**MONTGOMERY COUNTY HISTORIC PRESERVATION COMMISSION**  
**STAFF REPORT**

<b>Address:</b>	7211 MacArthur Blvd., Bethesda	<b>Meeting Date:</b>	2/11/2026
<b>Resource:</b>	Contributing Resource <b>Potomac Overlook Historic District</b>	<b>Report Date:</b>	2/4/2026
<b>Applicant:</b>	Jeong Kim	<b>Public Notice:</b>	1/28/2026
<b>Review:</b>	HAWP	<b>Staff:</b>	Dan Bruechert
<b>Permit No.:</b>	1126423 REVISION	<b>Tax Credit:</b>	Partial
<b>Proposal:</b>	Door Replacement

The applicant proposes to remove and replace an existing door.

8 Proposed door

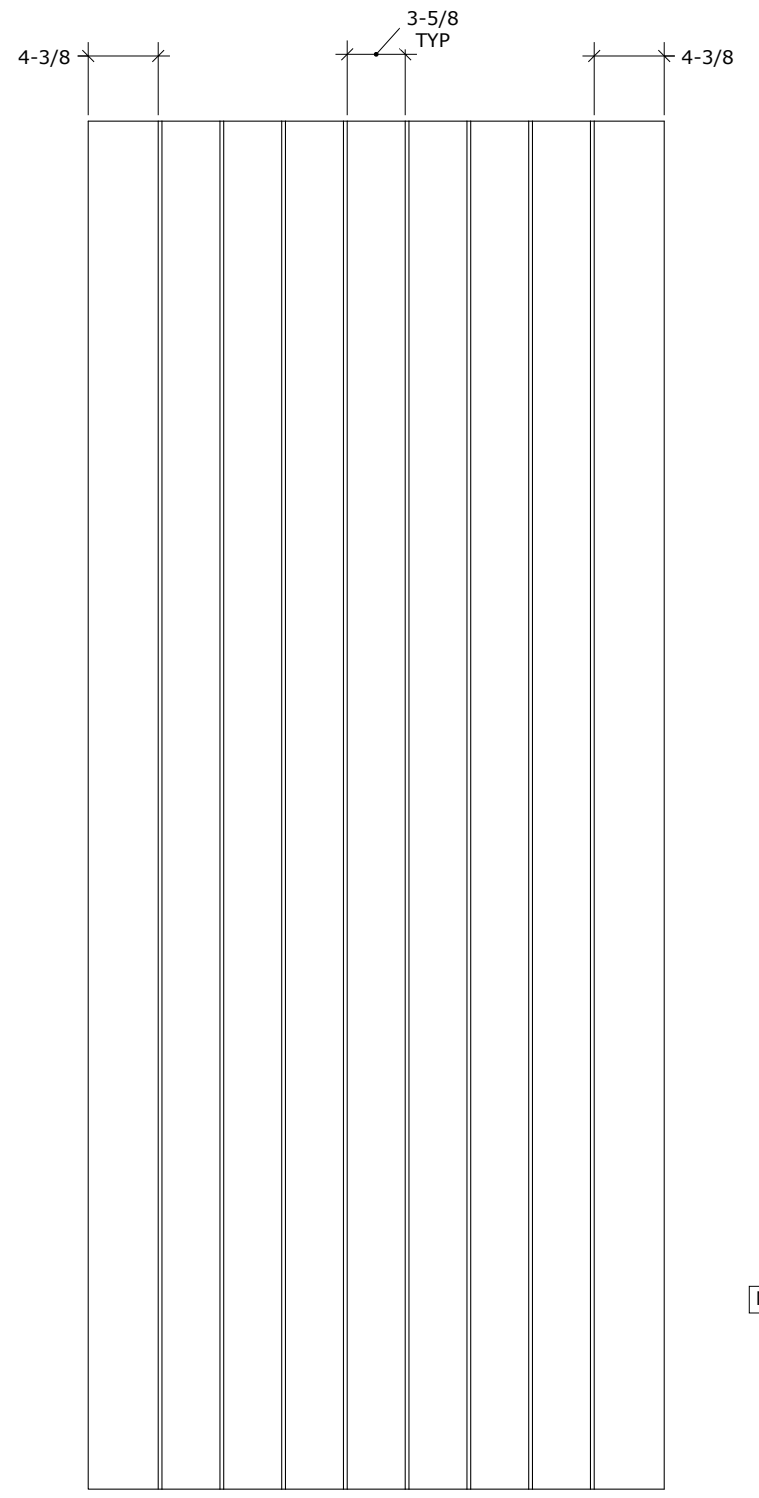
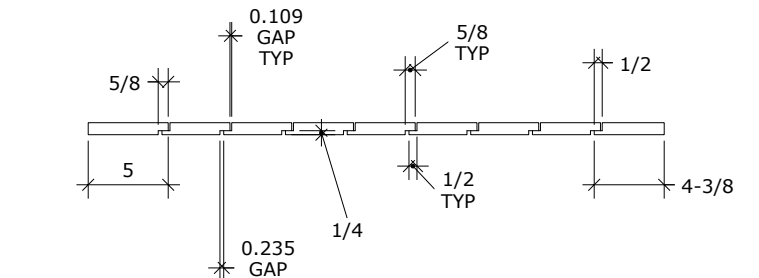
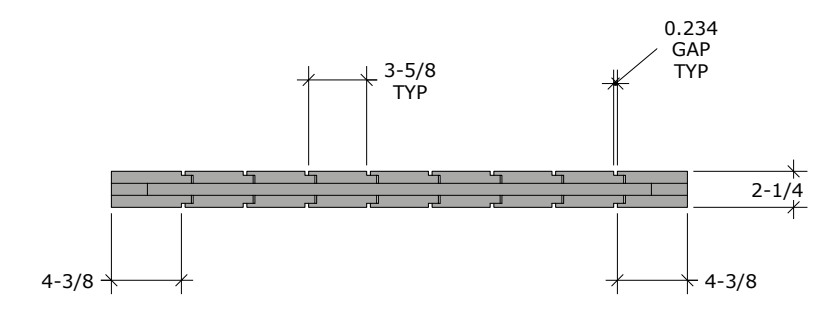
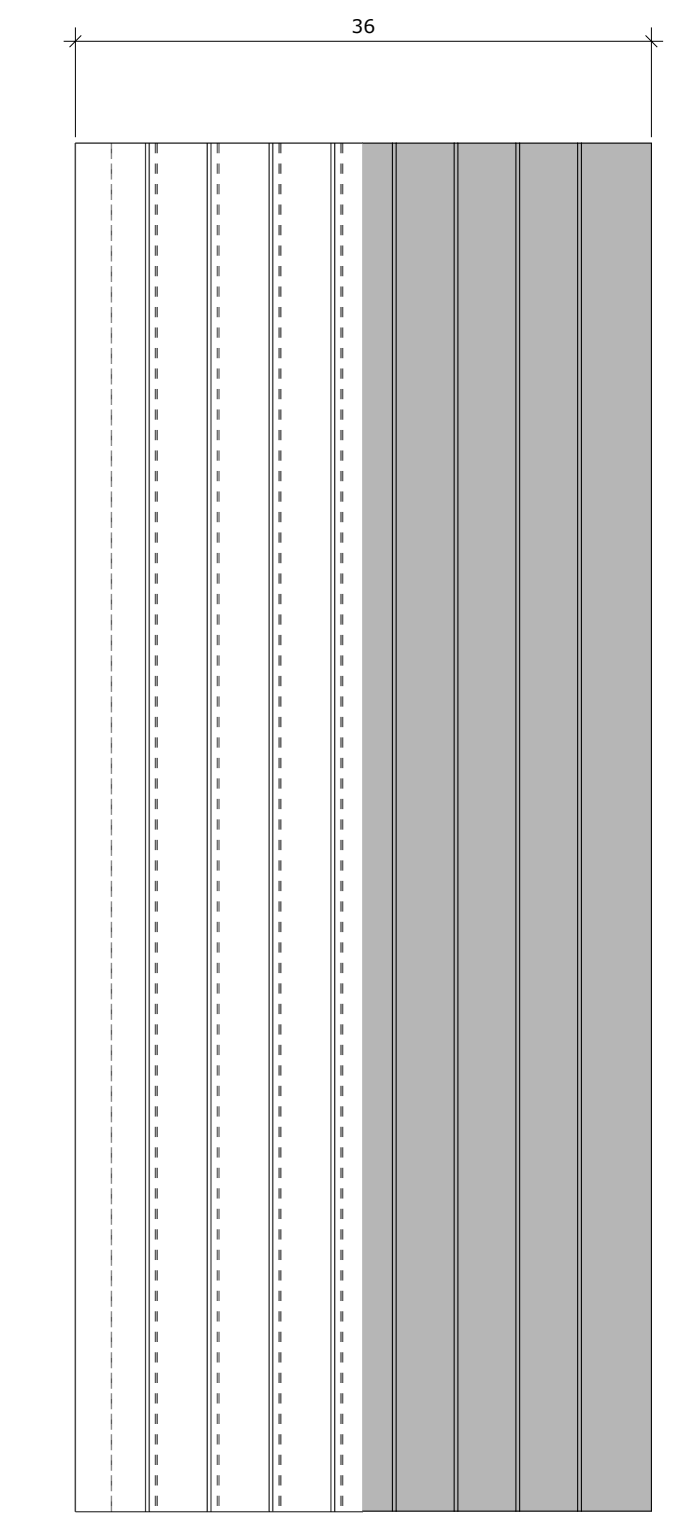
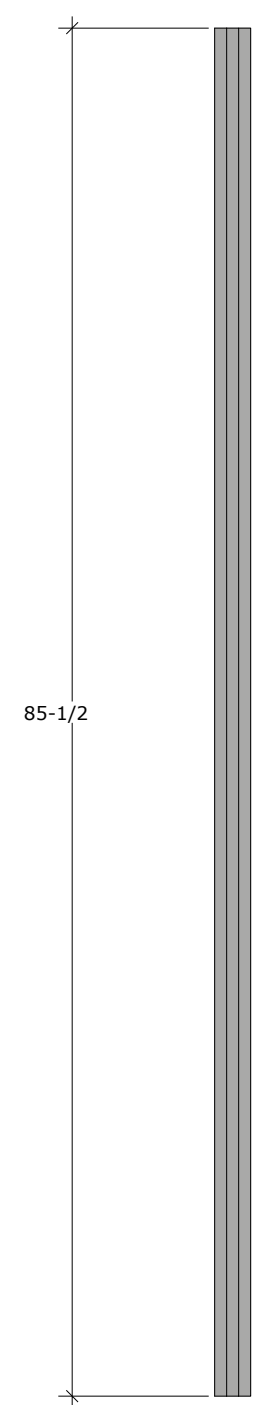
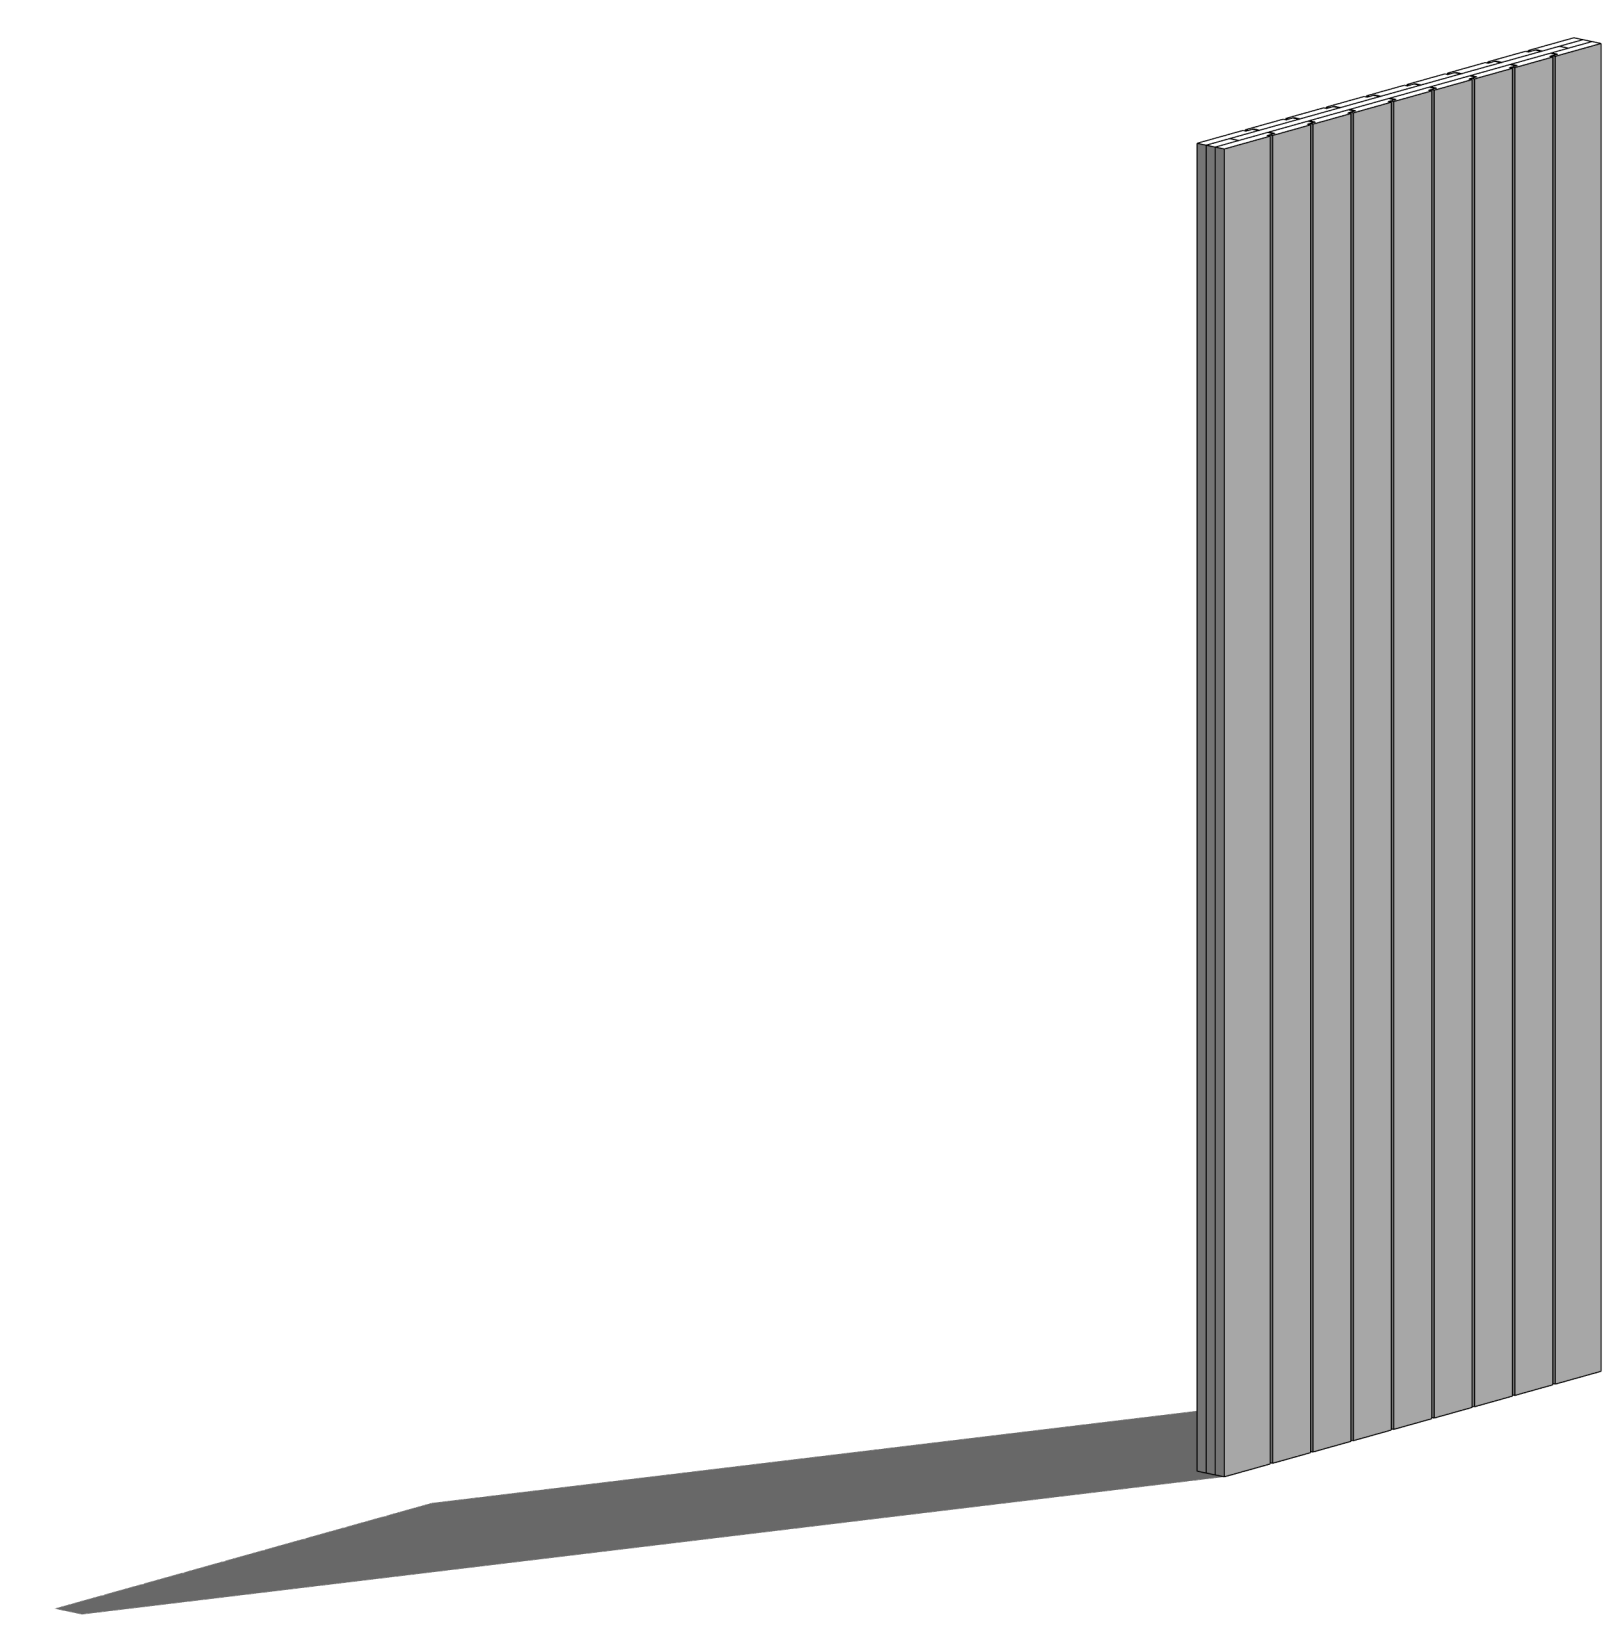
A reference image is included in this application, along with shop drawings from a current construction project in the Hollin Hills Historic Overlay District that was previously approved by the applicable historic preservation and architectural review boards. The proposed door will be very similar in design and detailing, with dimensions adjusted to fit the existing rough opening. Please note that for this project at 7211 MacArthur Boulevard, the side window adjacent to the door is smaller, as shown in the previously submitted drawings.

The proposed door consists of vertical solid mahogany wood boards, without panels or divided lights, finished with a clear satin exterior finish.

EXISTING DAMAGED DOOR TO BE REPLACED

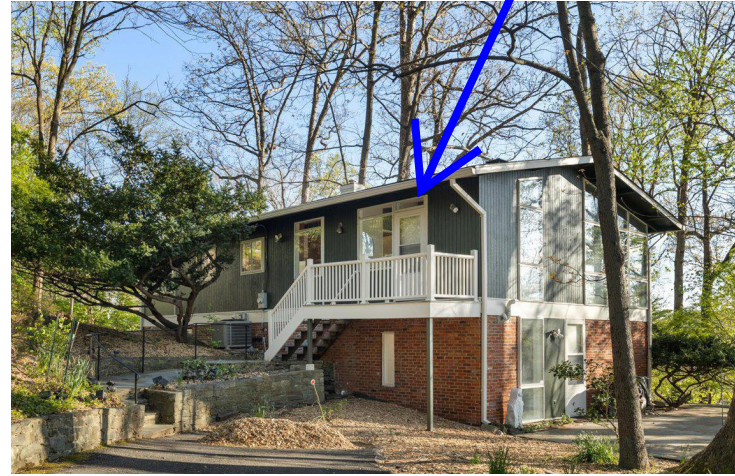
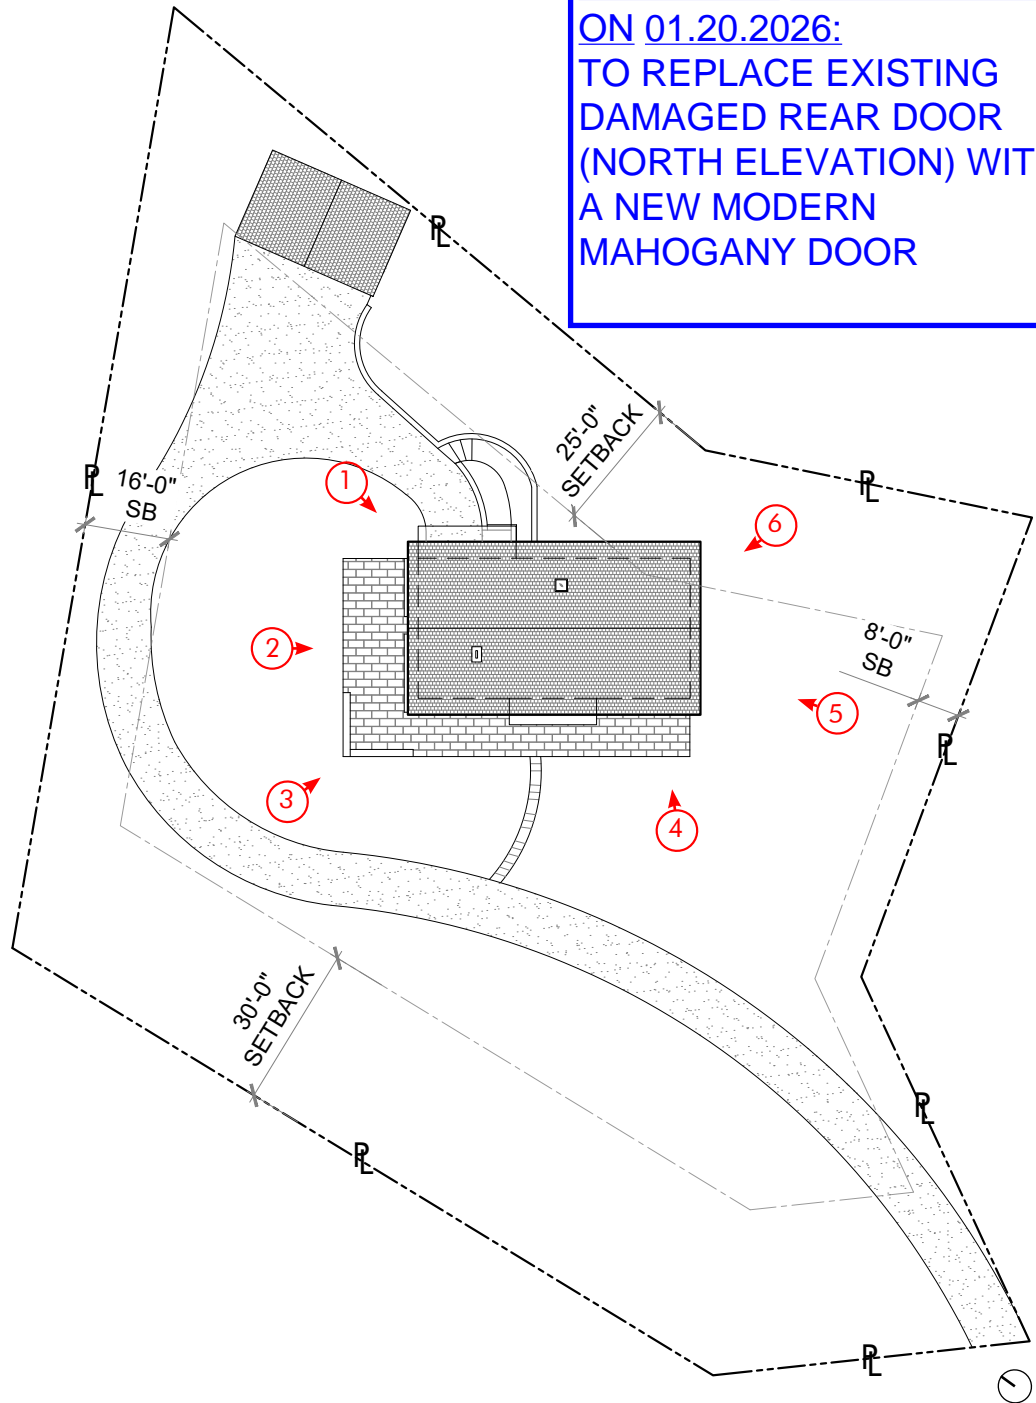
The existing rear entry door located on the northern elevation has been found to be in poor condition. The proposed amendment revises the scope of work to include replacement of this exterior door with a new compatible door that aligns with the contemporary architectural vocabulary of the Potomac Overlook District. Although located at the rear of the house, this door will function as the primary entry door for the homeowners.

Work Item 2: <u>AMEDNMENT TO REAR EXTERIOR DOOR (NORTH ELEVATION) 01.20.2026</u>	
Description of Current Condition:	Proposed Work:
<u>REAR EXTERIOR DOOR ON NORTH ELEVATION IS WORN AND DETERIORATED; NEEDS REPLACEMENT</u>	<u>EXTERIOR DOOR TO BE REPLACED WITH NEW SOLID MAHOGANY DOOR, FINISHED WITH CLEAR SATIN EXTERIOR FINISH, AND PROVIDED WITH STAINLESS STEEL KNOB, DEADBOLT, AND SQUARE-EDGE HINGES</u>

PROPOSED NORTH ELEVATION

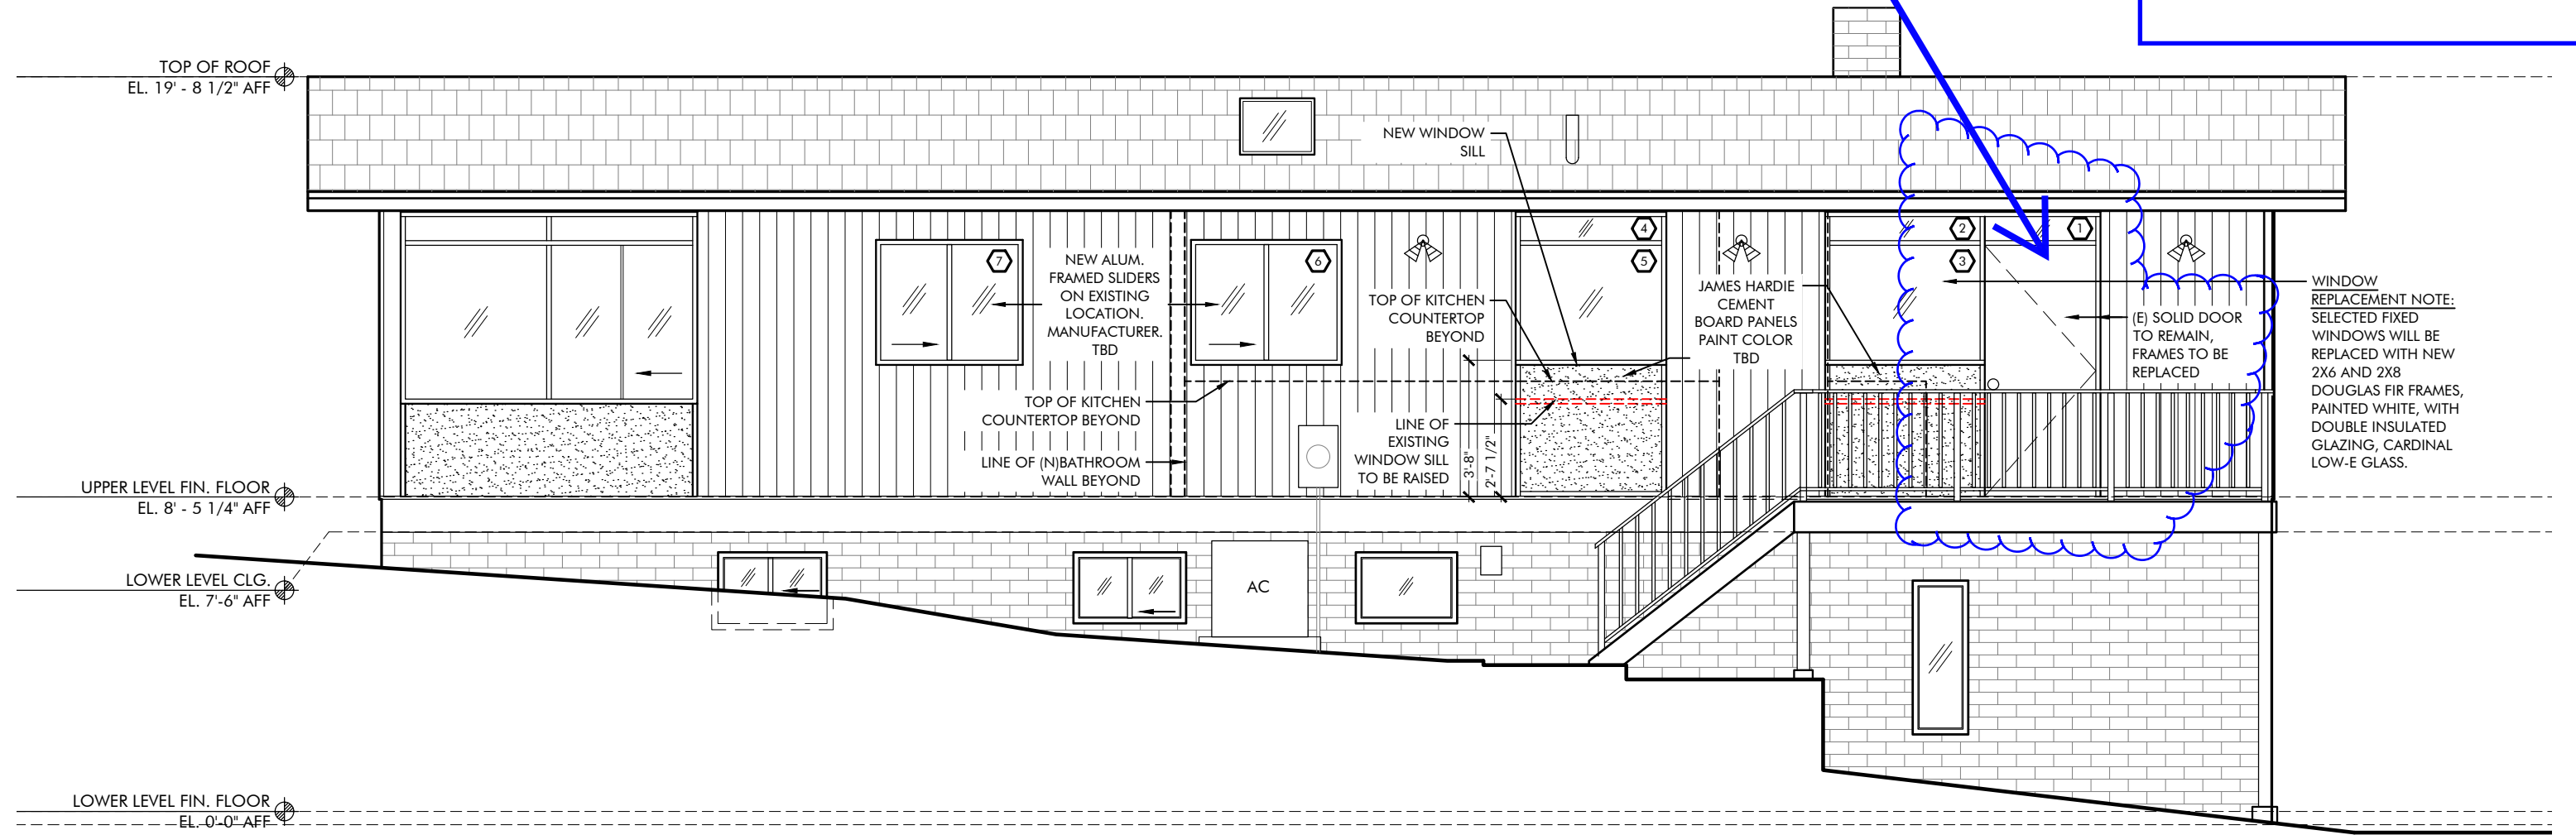
EXISTING DAMAGED DOOR TO BE REPLACED
